Waterfront Kiosks

Meeting Summary

June 18, 2015

Design Development

Figure 3. Diagram of the kiosk geometry

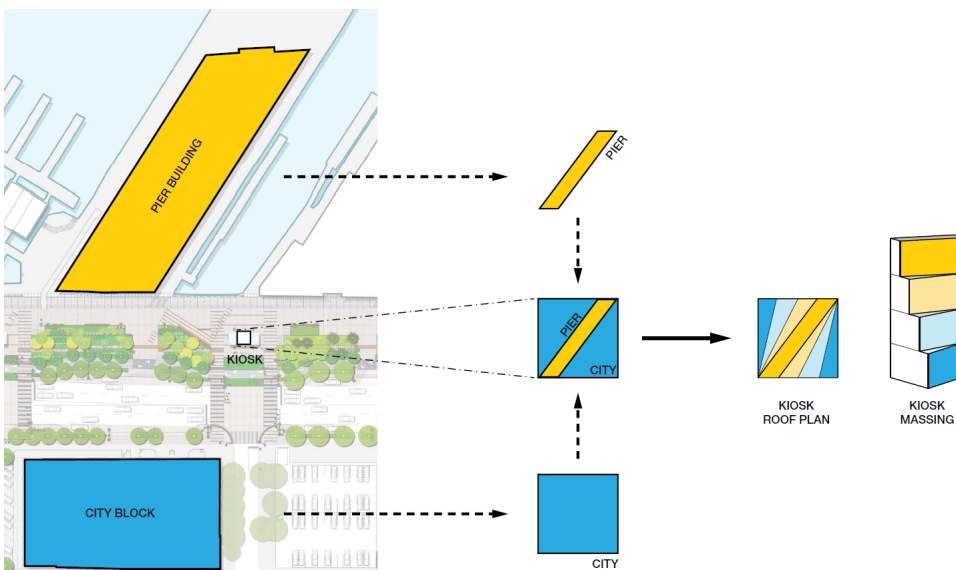
Given the detailed analysis of reflections, views, and alternative forms included in the presentation, the Commissioners believed that the kaleidoscope idea had evolved into a compelling design. There was concern that the illustrations did not include trees, preventing the Commissioners from considering the kiosks in context with the proposed Waterfront Seattle landscape design. Nevertheless, the Commissioners agreed that, while scale is subjective, the proposed dimensions seemed appropriate in context with other structures on and around the waterfront.

Figure 6. The Commission recommended rotating the Union St kiosk if doing so would support the intended program.

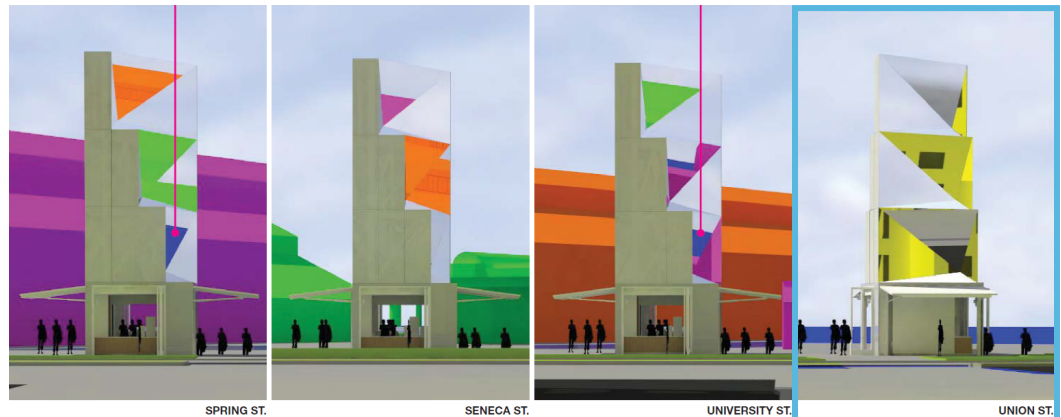
4. Continue to study the alternative orientation for the Union St kiosk, as shown in Figure 6, and evaluate the extent to which the rotation would increase the variety of reflections visible in the kiosks without obscuring the view west along Union St towards Elliott Bay. The Commission recommends that the program inform the decision whether to rotate the ground-level portion of the Union St kiosk.
